## SERVICE BULLETIN MAINTENANCE OF WAY EQUIPMENT

**DATE:** 8-8-2002 **BULLETIN NO:** 02-020

**TITLE:** 200022 PRE-SQUEEZE POTENTIOMETER

**PRODUCT SERIES / MODEL:** RMC306 Series A / B ANCHOR BOXER<sup>®</sup> Anchor Applicators

**FIGURE 1**  
**PRE-SQUEEZE POTENTIOMETER INSTALLATION**  
 Outside of Control Box Cover - All Models Except B2-27 and Brainerd Rebuilt

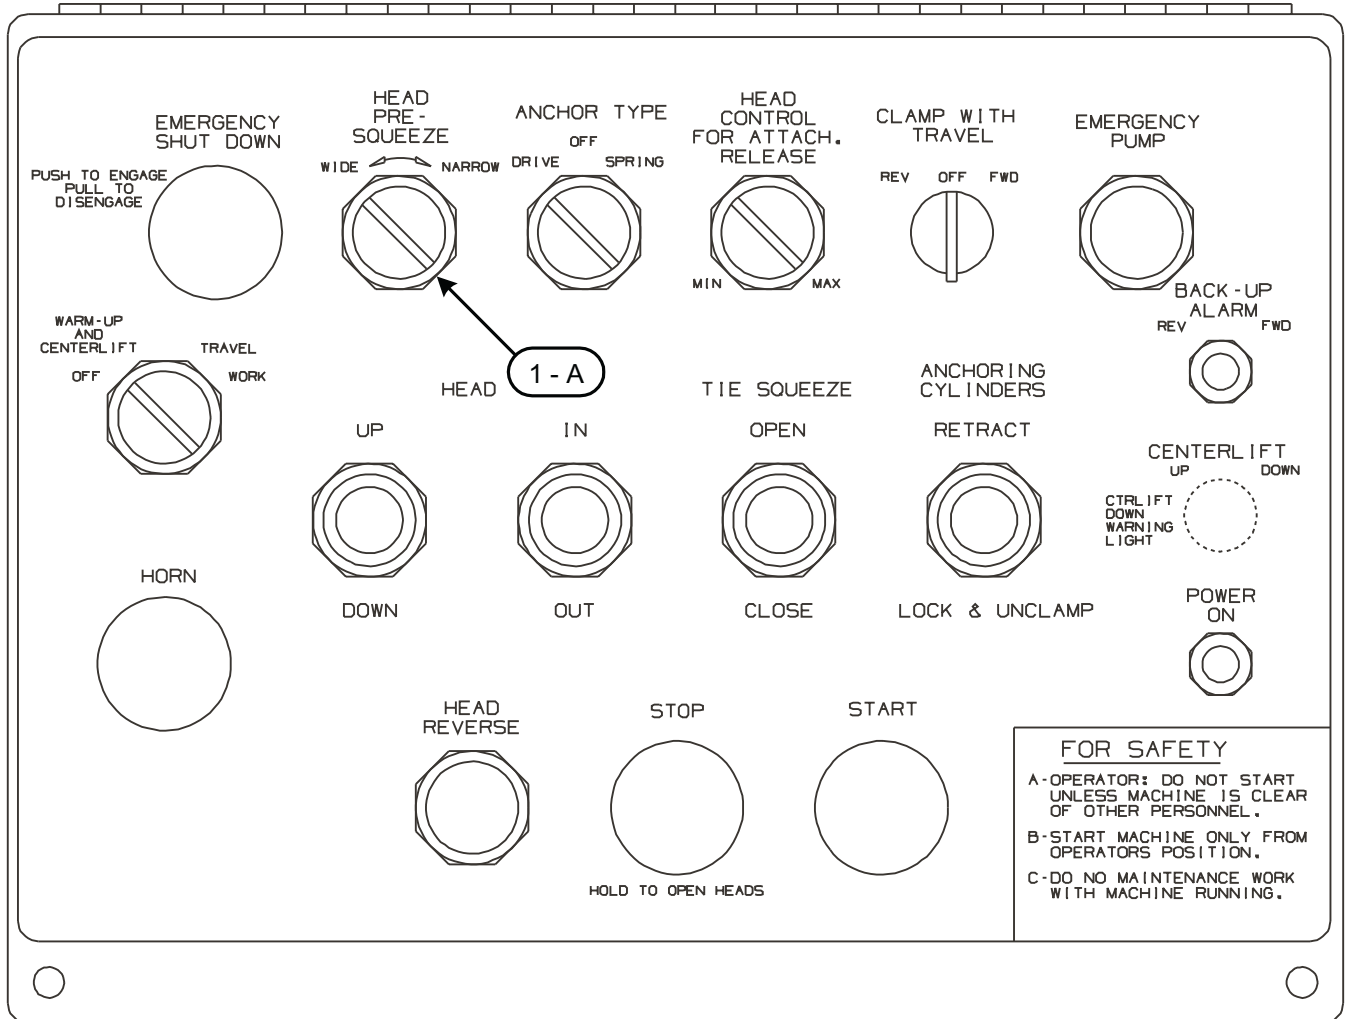
**SUMMARY:** If the original pre-squeeze timer relay part # 502663000 was replaced by a new pre-squeeze timer relay part # F026006, the original pre-squeeze 150k potentiometer part # 108329000 marked 800T - U50 - 0.15 mΩ (meg ohms) must be replaced with a new pre-squeeze 500k potentiometer part # 200022 marked 800T - U55 - 0.5 mΩ (meg ohms) for the new timer relay to operate properly. See Service Bulletin 02-016 to change the pre-squeeze timer.

The original 150k potentiometer allows the new timer relay to operate for about 1/3 of a second and as a result the anchors may be left too wide during the pre-squeeze cycle. The anchors then have to be dragged farther in during the squeeze cycle which can cause the squeeze pressure switch to trip prematurely and apply the anchors to the rail before they are properly boxed against the sides of the tie.

1. Remove the nut and knob from the existing pre-squeeze potentiometer (A) in the Control Box on the right side of the machine to remove the potentiometer (A) from the panel.

3. Install the new pre-squeeze potentiometer (1) in the panel and re-install the nut and knob finger tight. Verify that the knob points to the WIDE setting on the panel decal with the potentiometer turned fully counter-clockwise and to the NARROW setting on the panel decal with the potentiometer turned fully clockwise. Then tighten the nut to prevent the potentiometer from turning at the ends of its rotation.

FIGURE 3  
PRE-SQUEEZE TIMER RELAY LOCATION  
Inside of Control Box - All Models Except B2-27 and Brainerd Rebuilt

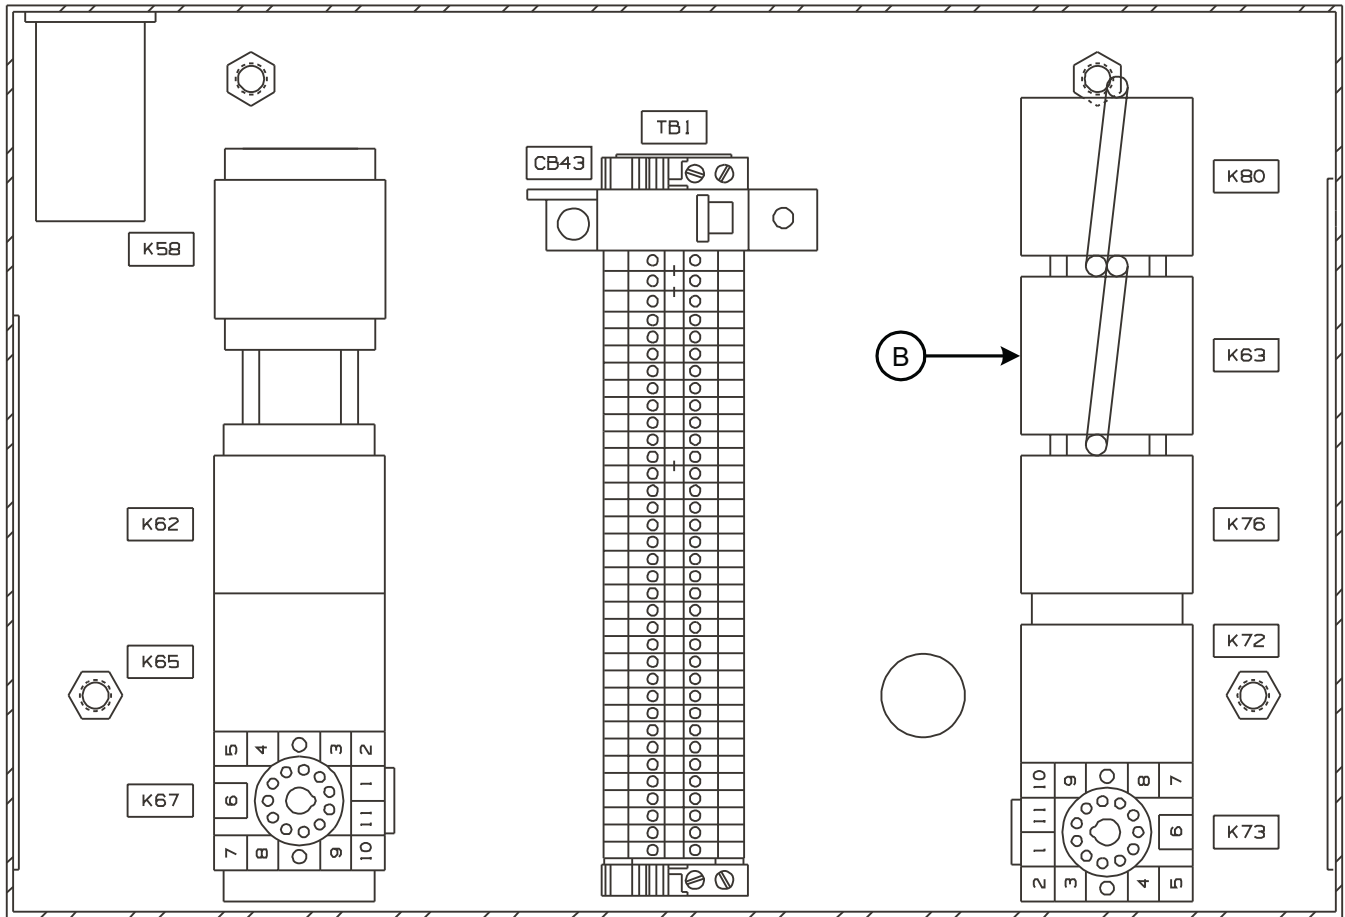
4. All Models Except B2-27 and Brainerd Rebuilt: Locate and verify that pre-squeeze timer relay K63 (B) part # F026006 is installed in the pre-squeeze relay socket inside of the Control Box. See Service Bulletin 02-016. Then close and secure the panel of the Control Box.

*Note: If the timer relay is any other color than black, it must be replaced with a new timer relay part # F026006 to work with the new pre-squeeze potentiometer.*

**FIGURE 6**  
**PRE-SQUEEZE TIMER RELAY LOCATION**  
Inside of Relay Box - Models B2-27 Only

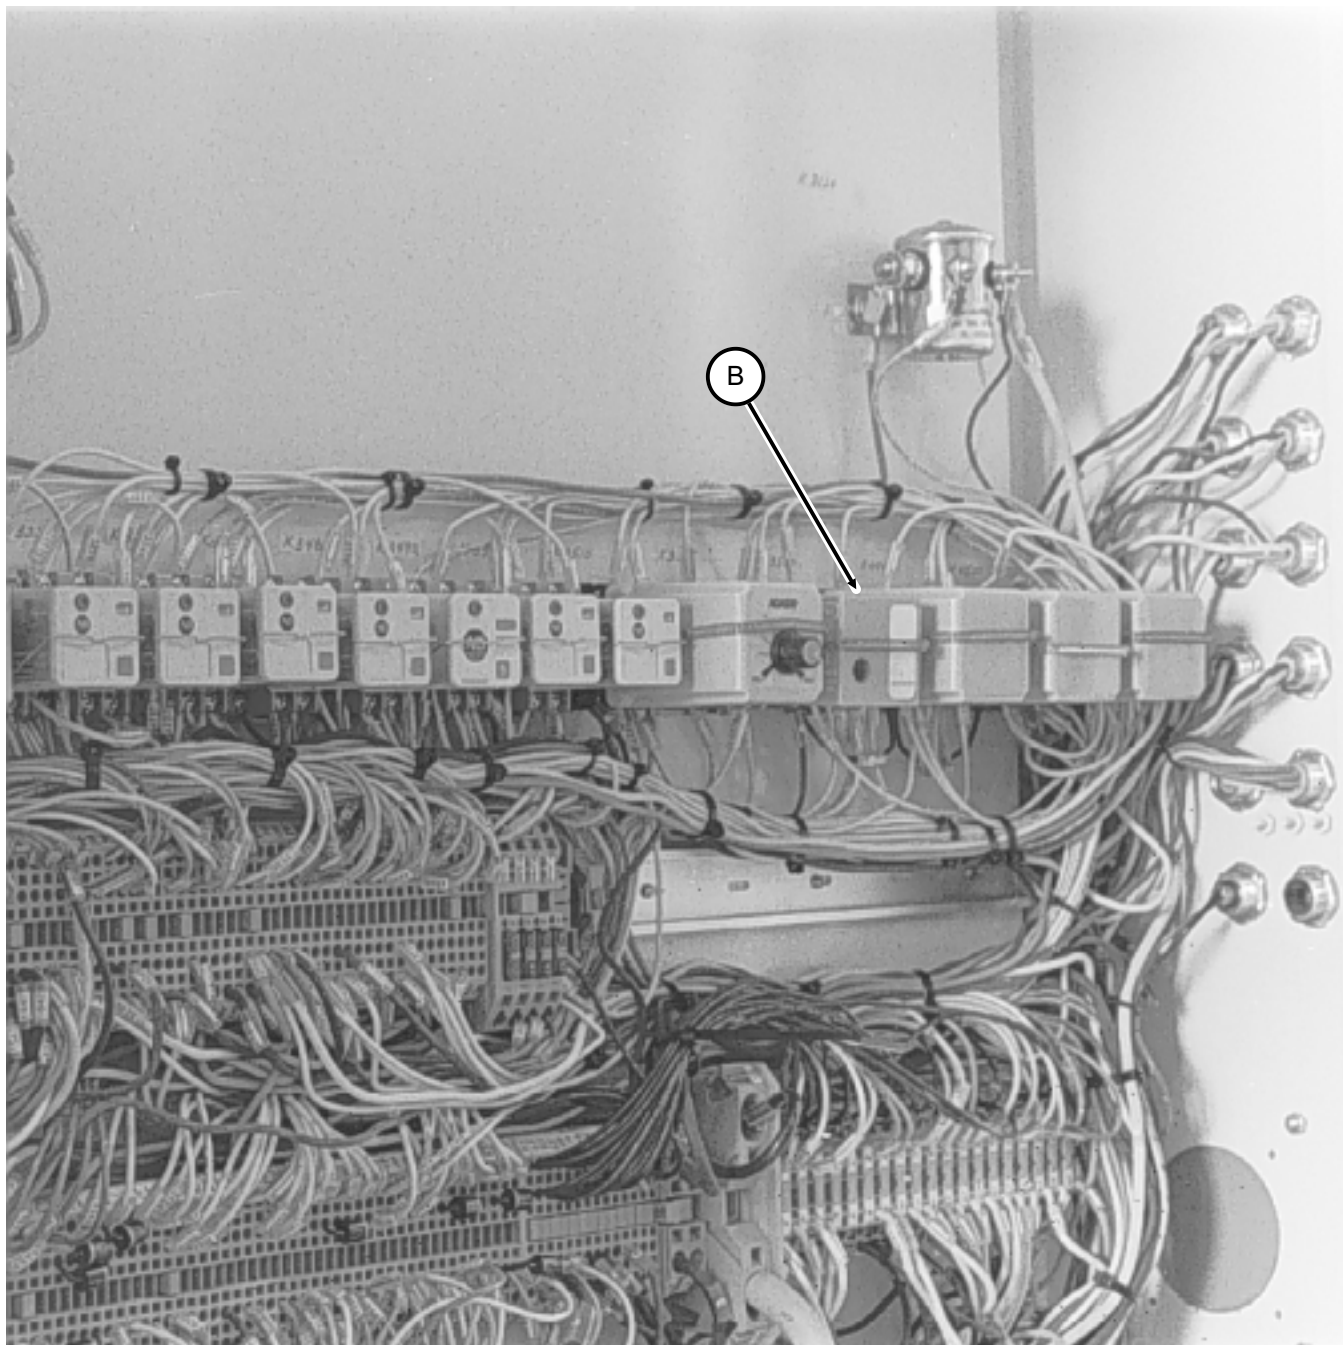
5. Models B2-27 and Brainerd Rebuilt Only: Close and secure the panel of the Control Box. Then open the cover of the Relay Box located on the rear of the machine next to the fuel tank. Locate and verify that pre-squeeze timer relay K3225 (B) part # F026006 is installed in the pre-squeeze relay socket inside of the Relay Box. See Service Bulletin 02-016. Then close and secure the cover of the Relay Box.

*Note: If the timer relay is any other color than black, it must be replaced with a new timer relay part # F026006 to work with the new pre-squeeze potentiometer.*
